Soybean Processing and Biodiesel Production Facility

(Approval No. 08_0083)

Section 75W Modification Application

November 2012

Figure 5 – Revised heat flux contours for proposed changes

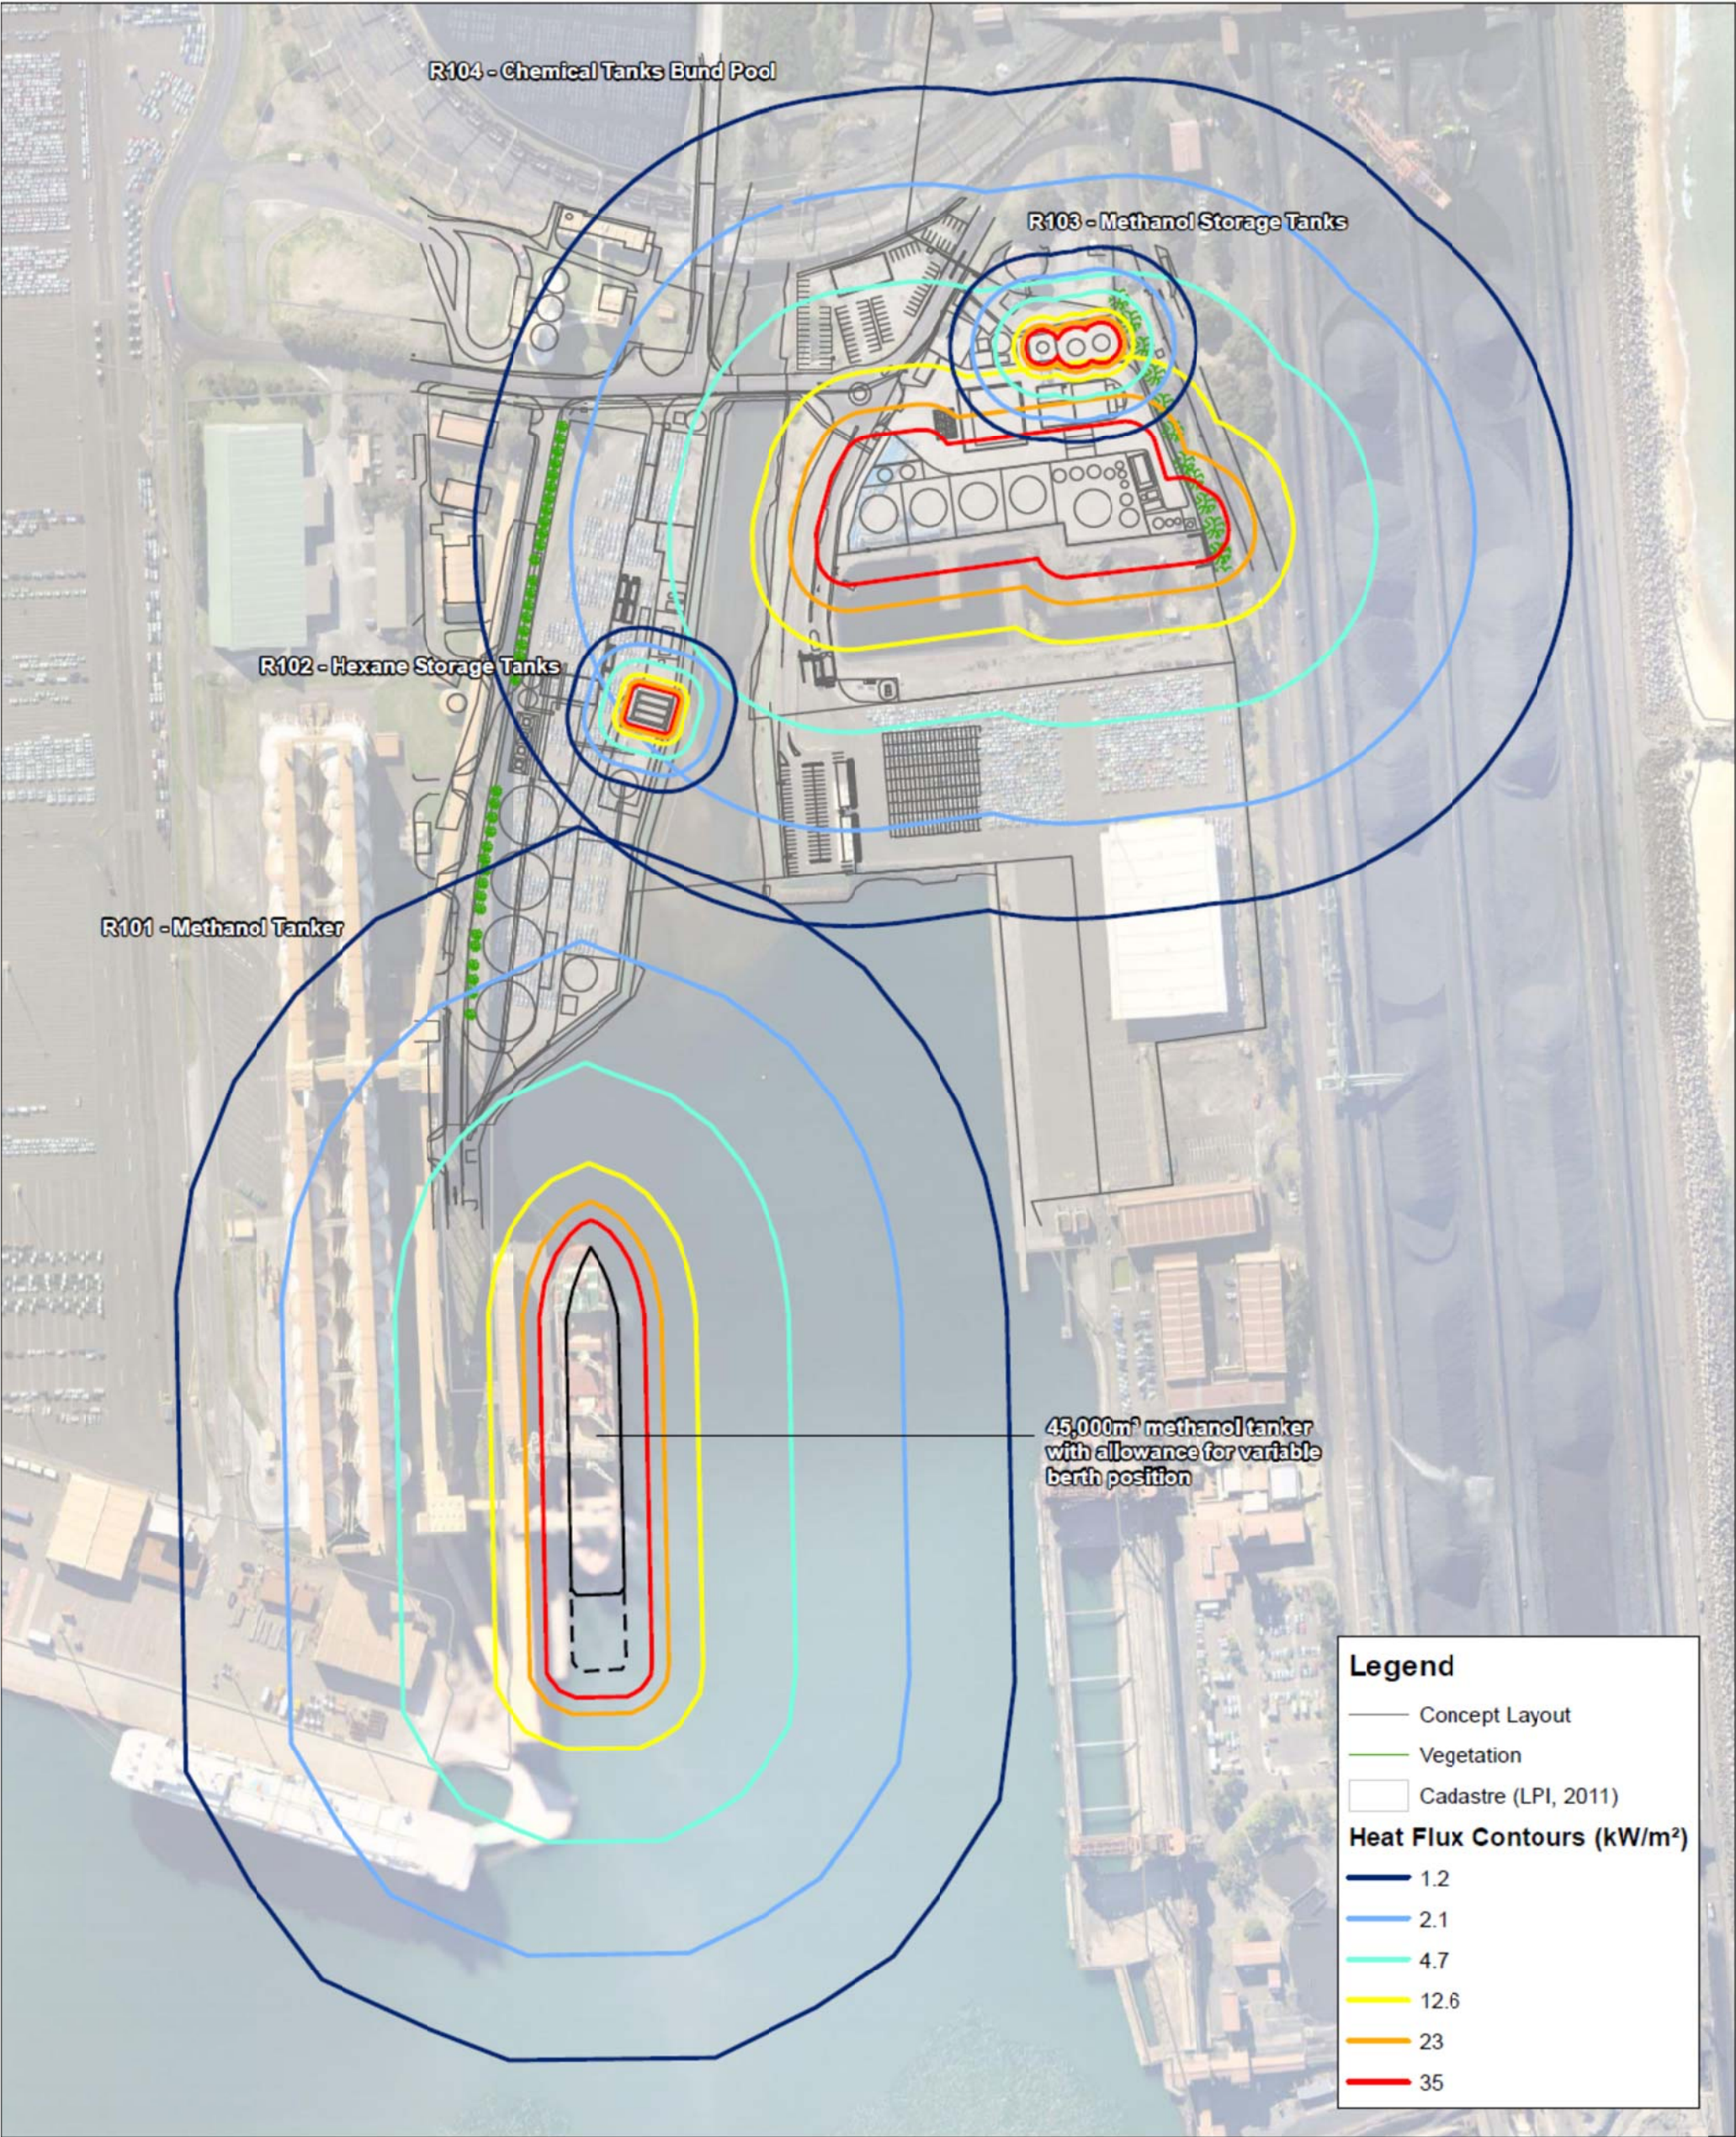
Revised modelling of the radiant heat fluxes associated with potential fires from bulk liquids on site was conducted as shown in Figure 5 on the following page. Contours R101, R102 and R103 detail radiant heat fluxes resulting from flammable liquid fires, the major risk identified with the proposed facility.

This revised heat flux diagram shows that the radiant heat impacts from a flammable liquid fire on the Biodiesel Refinery site (contour R103) for the new location of Plot 3 meets the following relevant risk criteria adopted in the original PHA in the Maunsell-AECOM (2008) EA:

Furthermore, the revised radiant heat flux contour R103 (flammable liquid fire on the Biodiesel Refinery site for the new location of Plot 3) showed that the associated radiant heat impacts on the neighbouring PKCT facilities are negligible; the modelled heat flux is a maximum of 4.7kW/m² at the edge of the water piping compound and near the edge of the western side of the PKCT access road. The heat flux at the PKCT water tank, pump house and the eastern side of the PKCT access road is 1.2kW/m² which is equivalent to being out in the hot sun in the middle of summer.

An additional heat flux contour, R104, was drawn in on this revised radiant heat flux diagram to understand the potential radiant heat flux effects on the adjacent PKCT coal stockpiles in the very unlikely scenario of a pool fire from the bulk combustible liquid (soy oil & biodiesel) storage tanks bund. This risk was not previously considered in the original Maunsell-AECOM (2008) EA because it is very unlikely to occur, for the following reasons:

Figure 12 – Revised site layout as seen from Viewpoint 1, Swan St

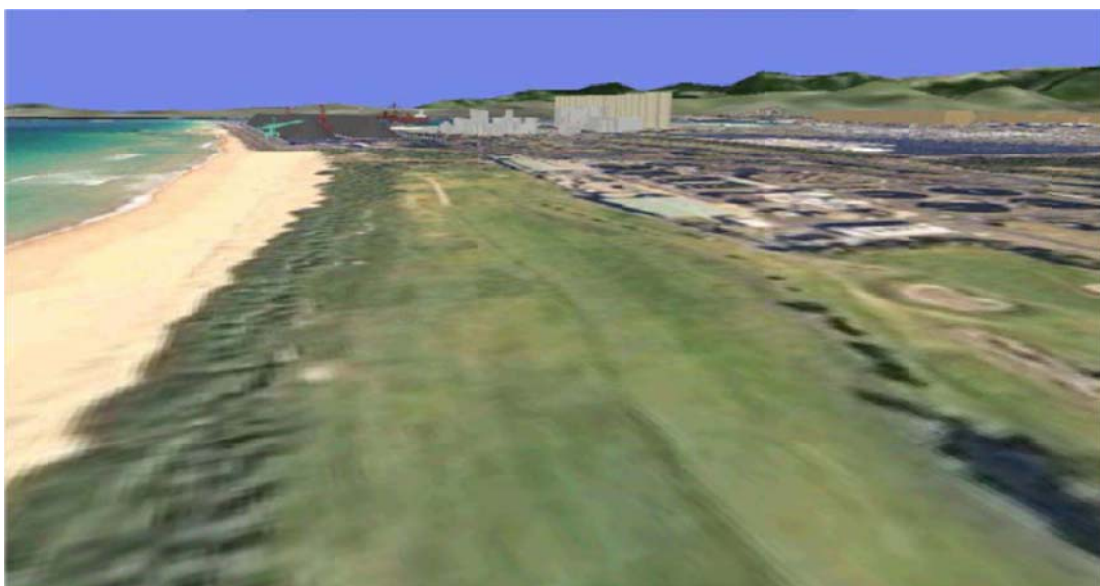
Viewpoint	Visual Modification	Visual Sensitivity	Visual Impact	Comments
1. Swan St	No perceived reduction in amenity	Regional	Negligible	Given the relative height of the existing grain silos, the proposed modifications are not considered to noticeably protrude beyond the extent of the existing structures.
2. Robwald Ave	No perceived reduction in amenity	Local	Negligible	The subject site is within close proximity to the existing Grain Terminal and accordingly is not considered to alter this viewpoint
3. Outer Harbour	No perceived reduction in amenity	Regional	Negligible	In general the proposed modification works are screened from the Outer Harbour by the Grain Terminal and PKCT
